## STAFF REPORT

### BARTHOLOMEW COUNTY PLAN COMMISSION (January 13, 2016 Meeting)

**Docket No. / Project Title:** MA/P-15-02 (Driftwood Center Section 1, Replat of Lot 7)  
**Staff:** Allie Keen  
**Applicant:** Edin-Apple, LLC  
**Property Size:** +/- 30.66 Acres  
**Current Zoning:** CR (Commercial: Regional & I-1 (Industrial: Light)  
**Location:** North and south sides of Hartman Drive on the west side of US 31, in German Township.

## REPLAT OF LOT 7 PRELIMINARY PLAT

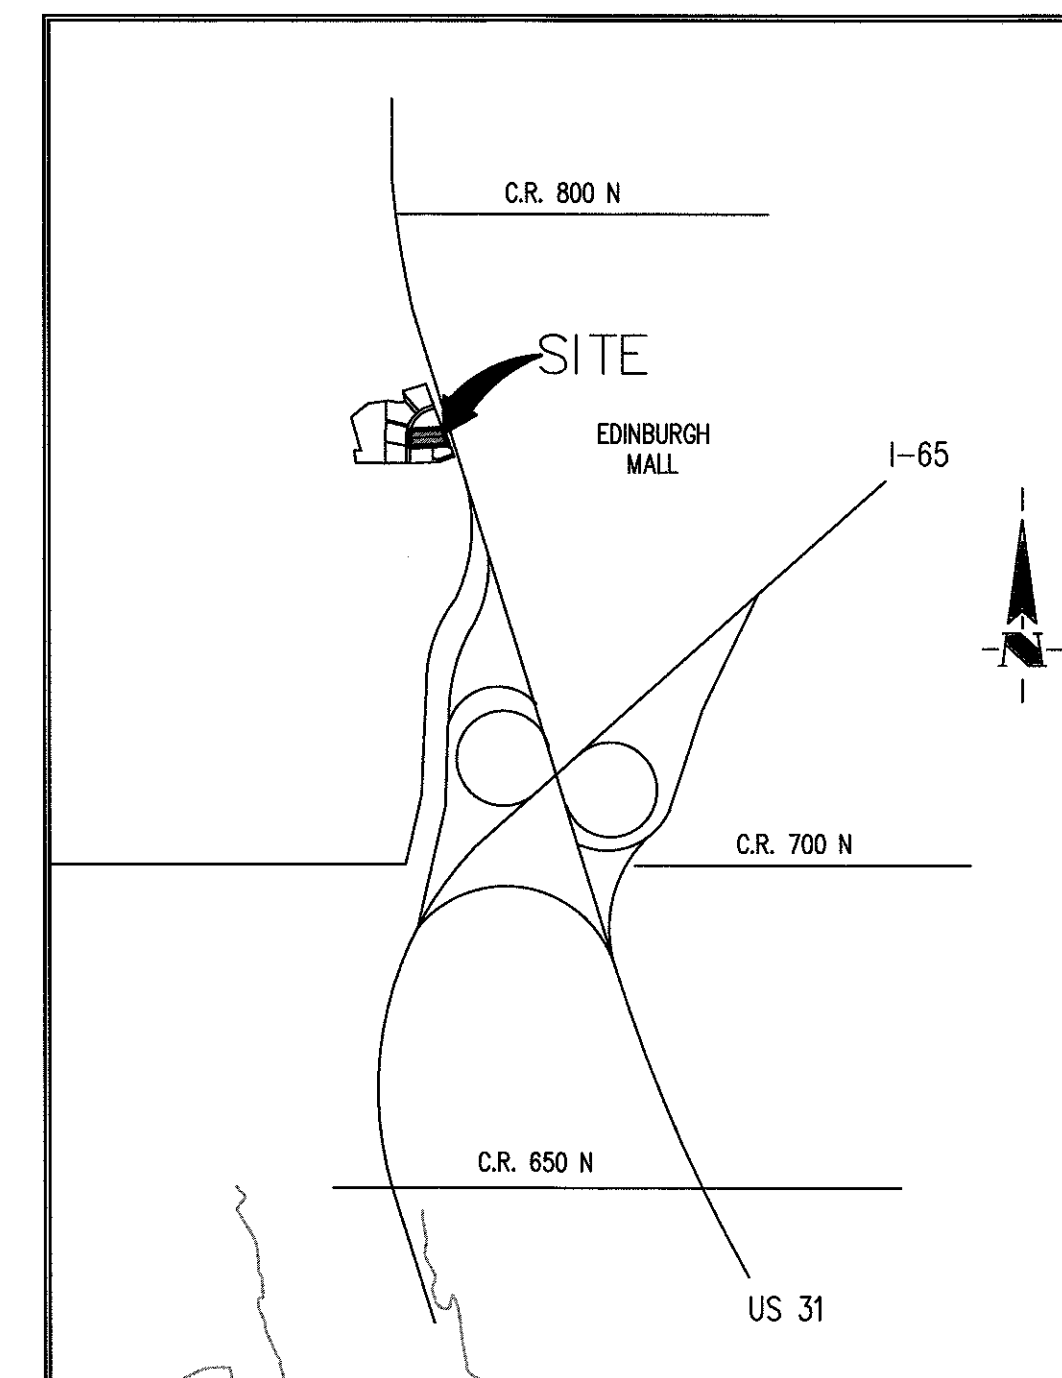
1. Is the proposed creation of the new lot consistent with the original approval and the Subdivision Control Ordinance?
2. Should the existing access to the frontage road be narrowed to one lane in order to discourage traffic from existing back onto the frontage road?

1. All traffic shall exit from Lots 6, 7A, 8A, 9, and 11 onto Hartman Drive. The frontage road shall only provide entry to these lots.
2. The access point serving lots 7A and 11 from the frontage road shall be narrowed to 15 feet in width to discourage motorists from exiting onto the frontage road.

3. A "Do Not Enter – Exit West to US 31 via Hartman Drive" sign shall be installed at the frontage road entrance for Lots 7A and 11 that indicates that it is entry only from the frontage road.

4. Sidewalks shall be installed along the frontage of Lot 7 (now lots 7A and 11), consistent with the approved Applebee's site plan (B/ZC-14-20-Oct.) site plan along the Hartman Drive and the frontage road frontages prior to the approval of the next final plat (including that for this additional lot) within the Driftwood Center major subdivision.

5. All pavement markings on Lot 7 (now Lots 7A and 11) shall be removed except for one pointing to the west located at the frontage road entrance, prior to the approval of the next final plat (including that for this additional lot) within the Driftwood Center major subdivision.

<b>Interdepartmental Review:</b>	
<b>County Highway Engineer:</b>	<ol style="list-style-type: none"> <li>1. The initial drainage plan included the second building site, so the drainage is adequate for the proposed preliminary plat.</li> <li>2. As suggested at the previous Plan Commission meeting, County Highway would like the entrance off the frontage road to be narrowed to help reduce traffic coming out to the east, as well as signage and pavement markings. I believe a width of 15 feet would be enough to allow delivery trucks but still discourage exiting onto the frontage road.</li> </ol>
<b>Health Department:</b>	No comments.
<b>County Fire Inspector:</b>	No comments.

3. This subdivision currently gains access from Hartman Drive and US 31 via a frontage road. The frontage road provides access to lots 6, 7, 8A, 9, and the new lot (Lot 11). The remaining lots within Driftwood Center gain access from Hartman Drive. There was a condition of approval with the original preliminary plat of this subdivision that stated the frontage road could only provide entry to these lots but no exit. Traffic was to exit onto Hartman Drive to access US 31. This condition was intended to prevent motorists from accessing US 31 at Heflin Park Road, which is not at a signalized intersection. According to the provided preliminary plat, these conditions will be applied to the new lot. The applicant has also indicated on the provided preliminary plat that there will be a "Do Not Enter" sign located at the access point serving Lots 7A and 11 to discourage motorists from exiting these two lots back onto the frontage road.

4. The County Highway Engineer has also recommended narrowing the existing driveway at this location to only 15 feet to discourage two-way traffic and further encourage exiting onto Hartman Drive rather than the frontage road. The current access point is 29 feet in width. Section 7.3(Part 1)(D)(2) of the Zoning Ordinance allows an access point to a commercial property to be no wider than 14 feet per lane where typical access is by passenger automobile and 20 feet in width per lane where access is by large vehicles. The current width of the access would allow for 2 lanes that are adequate for large vehicles. The County Engineer stated that the 15 feet in width should still be adequate to facilitate delivery trucks.
